**WEIRTON AREA WATER BOARD
BROOKE COUNTY, WEST VIRGINIA**

CONTRACT #1 – WATER TREATMENT PLANT

ADDENDUM #2

THRASHER PROJECT #010-01233

SHEET No.
5D

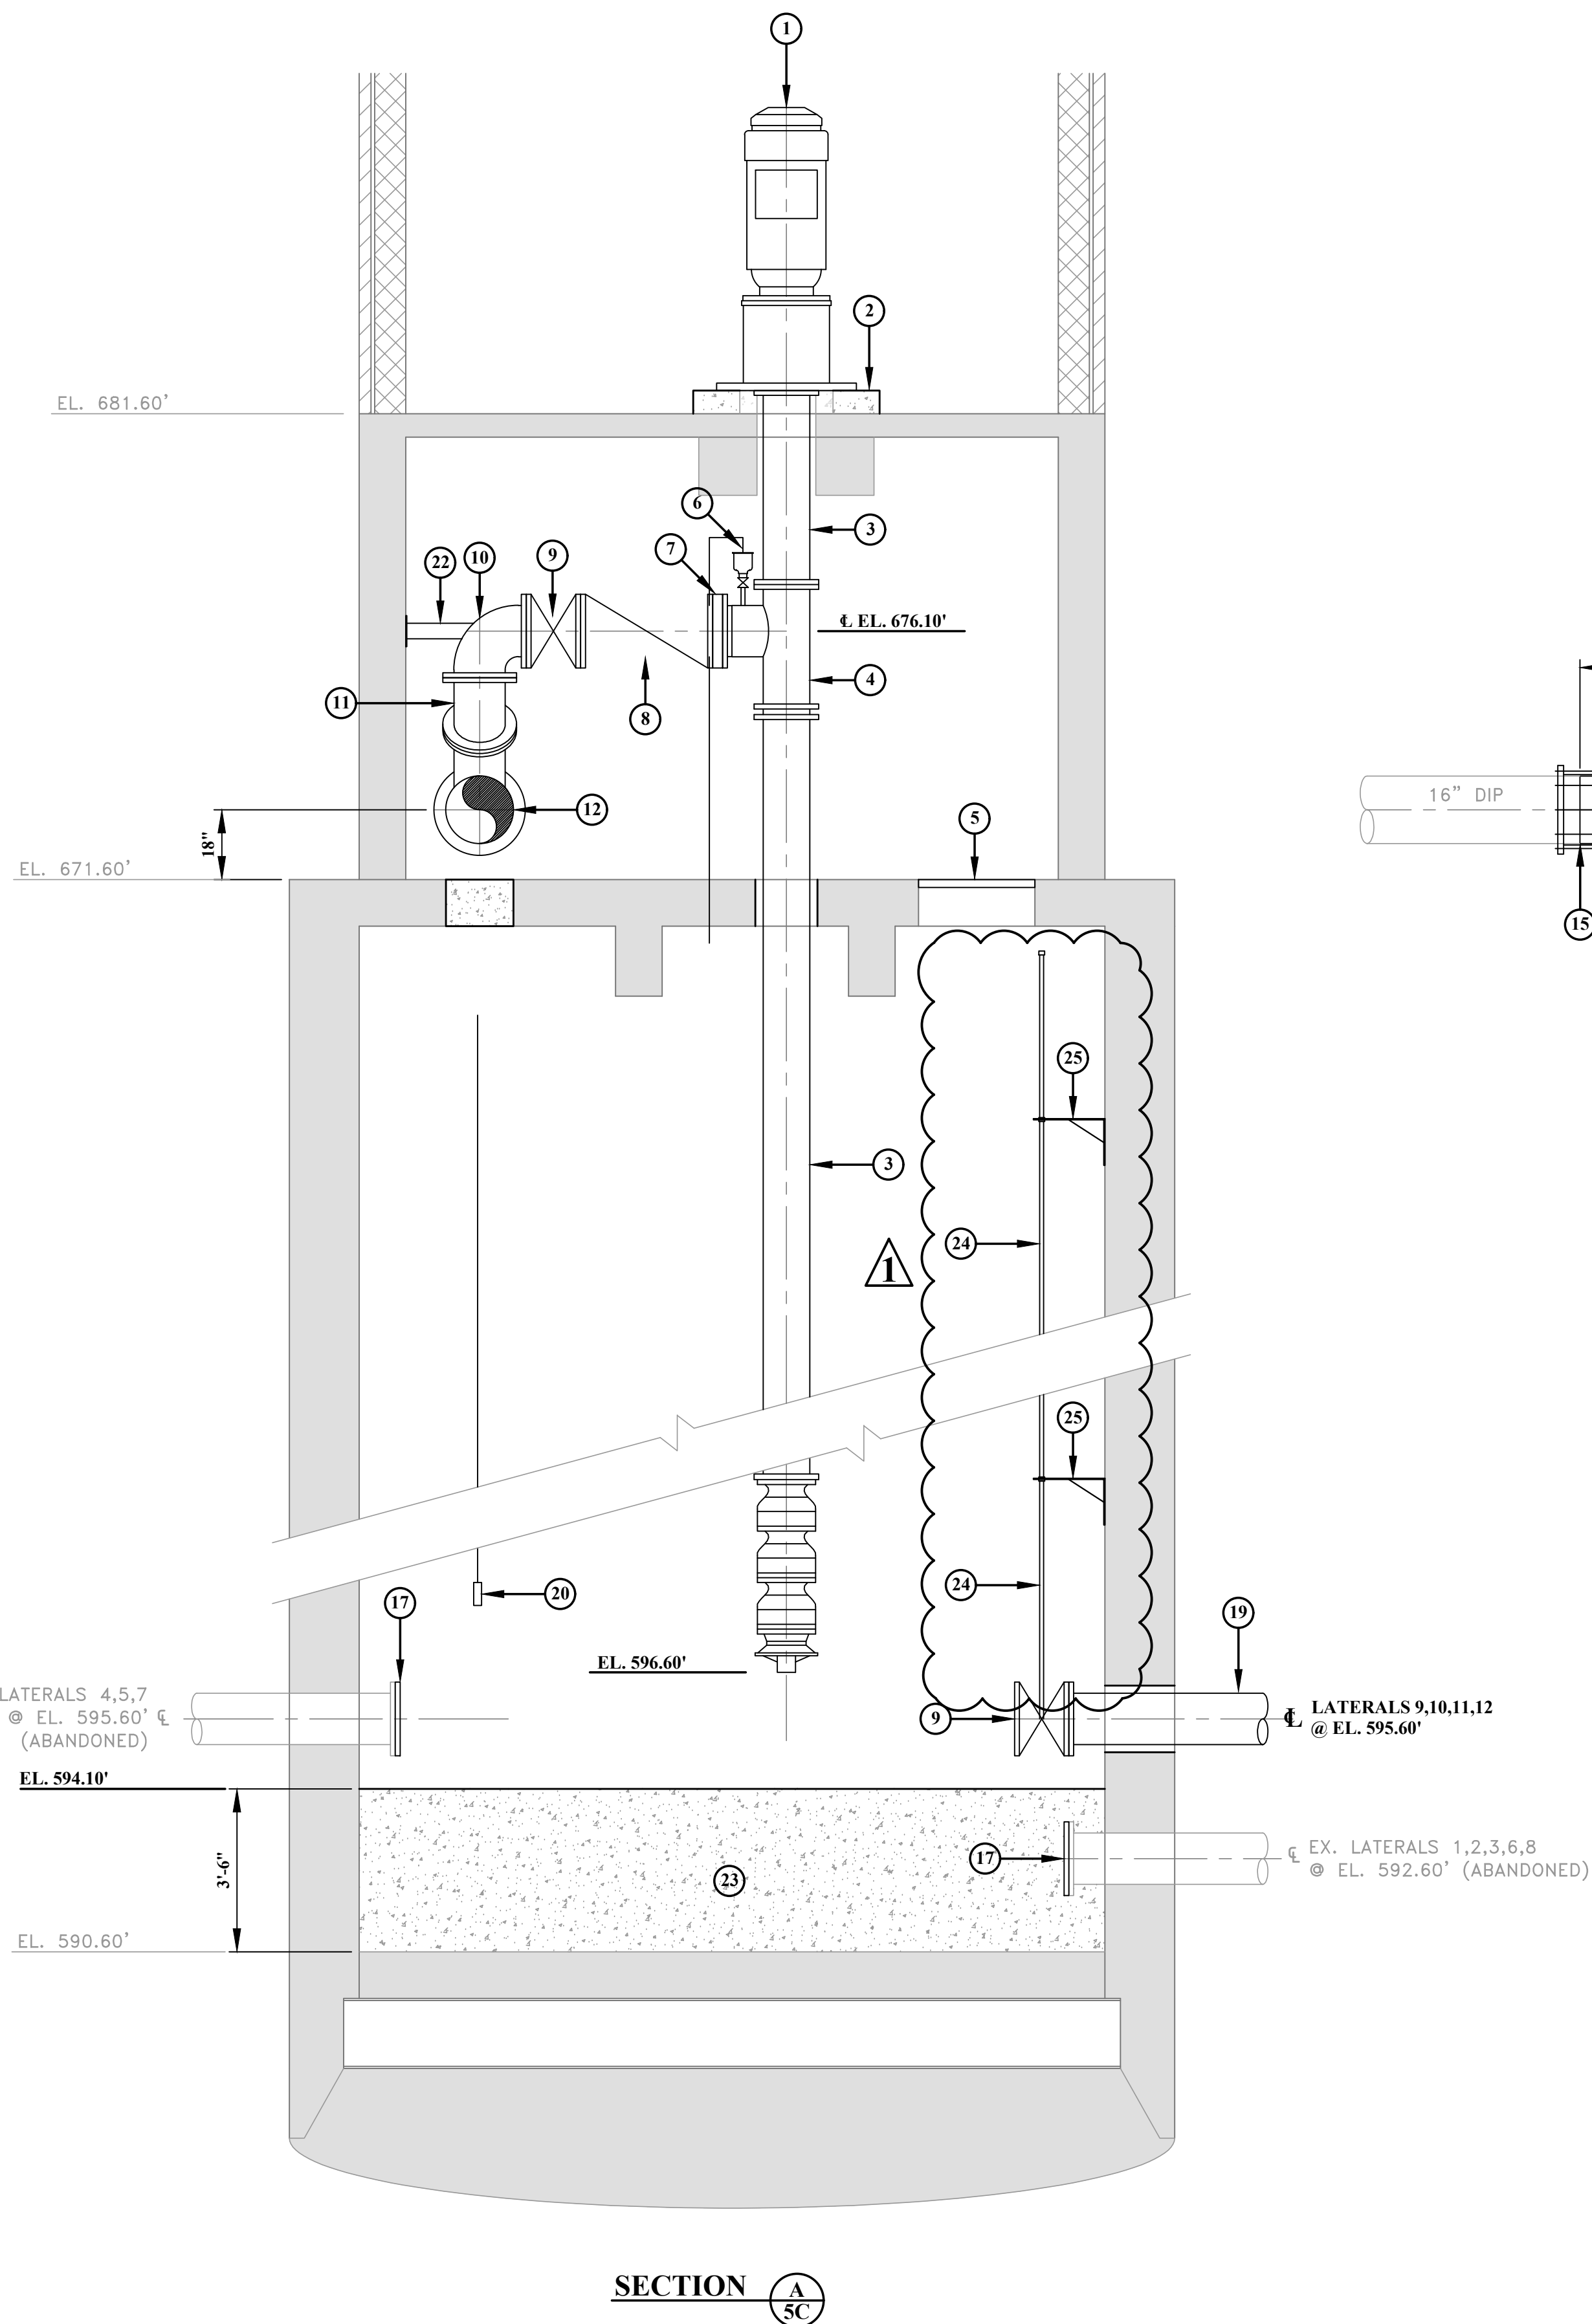
1. Reference Sheet 5A: **CHANGE** Legend so that hatching corresponds to “ITEM TO BE REMOVED”.
2. **REPLACE** Sheet 5D, included with this Addendum #2.
3. Reference Sheet 5E: **CHANGE** Key Note 1 to read, “12” D.I. GATE VALVE W/ VALVE STEM AND STEM SUPPORT BRACKETS.”

6. “Per Spec, Section 332100, Part 2.6 – Valves, there is no mention of valve stems just that the valves must be fitted with a 2-in. wrench nut. However, per drawing 5A, it calls out in the legend that the valves and valve stems are to be replaced (I’m assuming on the new lateral being installed), per their highlighted designation. Then, further back on drawing 5D, there is no mention of the valve stems being installed.”

- CONTRACTOR SHALL RAISE EXISTING CONCRETE BOTTOM BY 3'-6" BY FILLING WITH CONCRETE.
 - VALVE STEM. (TYP. OF 4) MATCH TO EXISTING ELEVATION OF EXISTING VALVE STEMS TO BE REMOVED. CONTRACTOR SHALL CORE EXISTING FLOOR AT STEM LOCATION.

- SUPPORT BRACKETS INSTALLED EVERY 15'. (TYP.)

Valve stems will need to be installed on the new well lateral valves. See Items #1-3 in the Drawings Section of this Addendum #2 and the revised Sheet 5D, also included with this Addendum #2. Requirements for valve stems are provided in Section 400561 – Gate Valves.

NO.	BY	DATE	DESCRIPTION
1	JLA	10-5-23	ADDENDUM No.1 - ADDED VALVE STEMS AND SUPPORT BRACKETS
